Section 96(1A) Development Application Statement of Environmental Effects

161 Sussex Street, Sydney

Section 96(1A) Modification 1 to SSD_7014

August 2016 ■ 15190

Figure 2 – Proposed amended Eastern Elevation
Source: Cox Architects

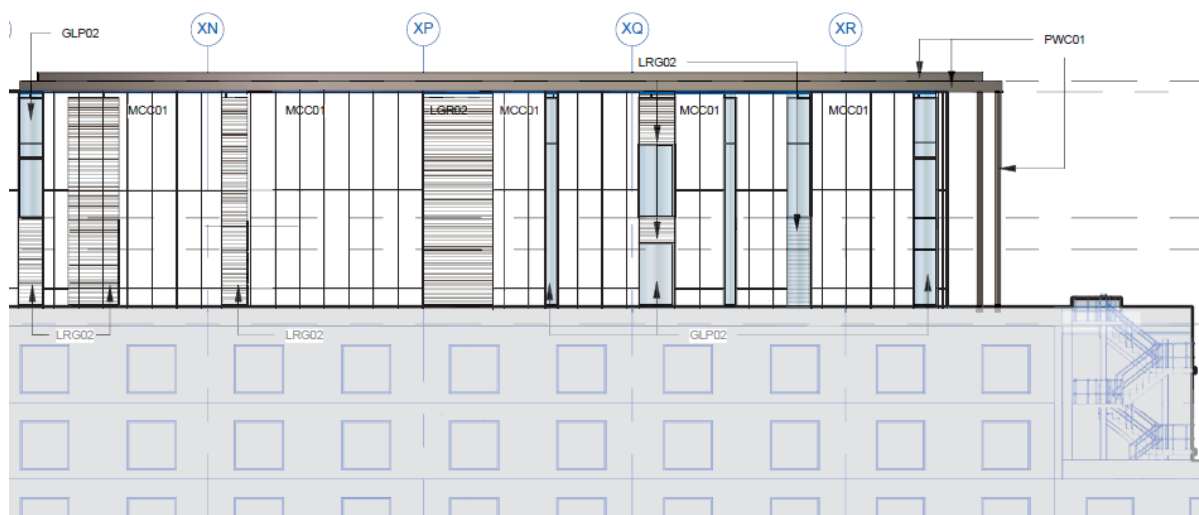
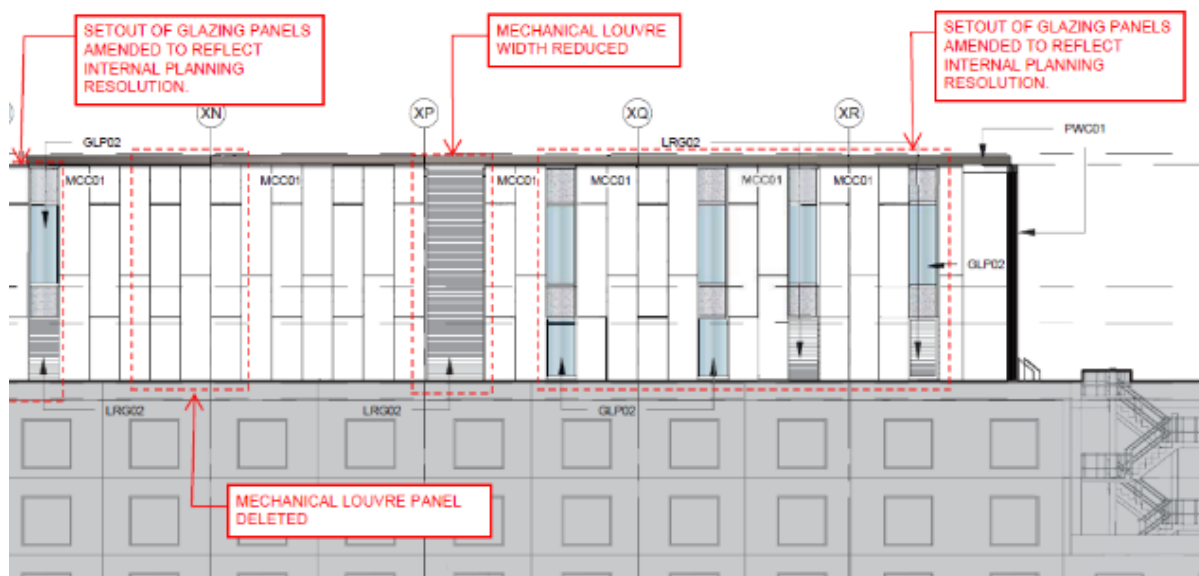
The proposal incorporates various minor amendments to external glazing, cladding, and plant louvres on all elevations, however the majority of changes relate to the eastern elevation, facing Sussex Street.

The overall number of window openings has been reduced from ten (10) to nine (9), which is a minor increase in width to some openings. This is a result of the coordination of the interior use of the spaces with the external appearance, which is a direct result of the detailed design development phase of the project. However it is noted that overall, the general level of glazing provided is consistent with the approval and does not give rise to any increased overlooking or visual privacy impacts to the neighbouring tower located to the east, on the opposite side of Sussex Street.

Further, minor amendments have been made to reduce the size, relocate or delete some external plant louvres. This corresponds with the design development and final specification of plant equipment for the building, which has recently occurred.

For a visual comparison of these external changes refer to **Figures 1 and 2** and the architectural drawings provided at **Attachment A**.

Figure 4 – Proposed amended Western Elevation

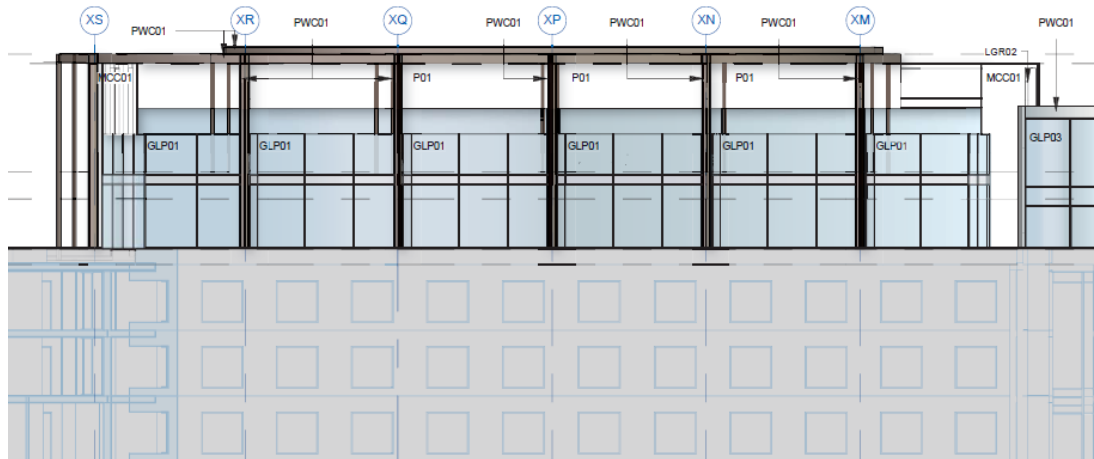
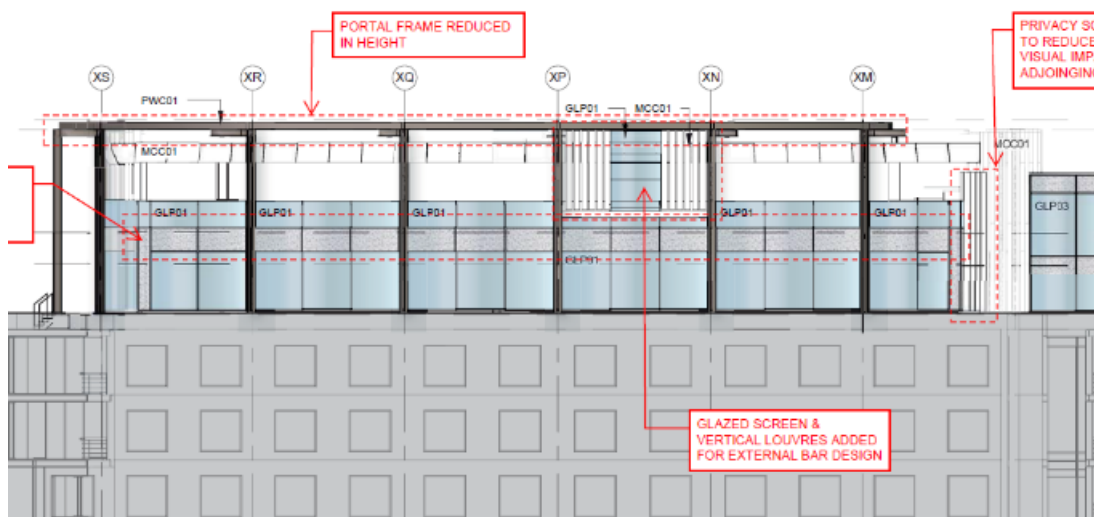
The western elevation is proposed to be modified to allow the addition of a glazed screen and two sets of white composite metal vertical louvres. The integration of these into the external structure are necessary as a backing to support the installation of the final interior bar design. Refer to **Figure 4**.

As noted above in **Figures 3** and **4**, the approved shadow box on the glazed curtain wall (or non-transparent glazed panel at slab level) has been increased in height on all facades. This modification is proposed in response to the design development phase for the structure and the desire to provide sufficient height in concealing the slab edge and associated services within this zone.

In addition, there has been a slight reduction in the height of portal frame roof structure. This is a minor revision to match the interior planning of the bar and lounge space and offers a more visually attractive space when viewed internally. Refer to **Figures 3** and **4**.

Figure 5 – Proposed addition of privacy louvres at the Roof Level (indicated in red outline)
Source: Cox Architects

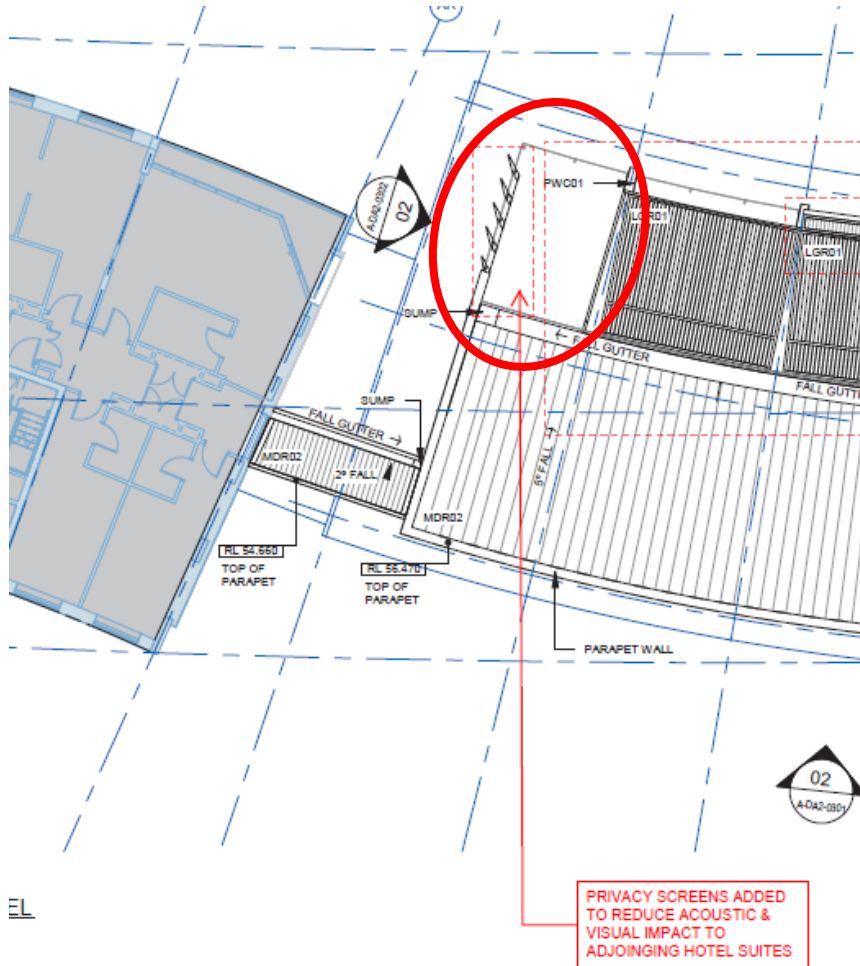
At the southern elevation of the bar and lounge structure, it is proposed to install fixed vertical louvres. These have been incorporated to minimise the potential for impact of the rooftop bar and lounge structure on the neighbouring hotel suites which are part of the same Four Points Hotel development. These louvres are indicated in red within **Figure 5** below.
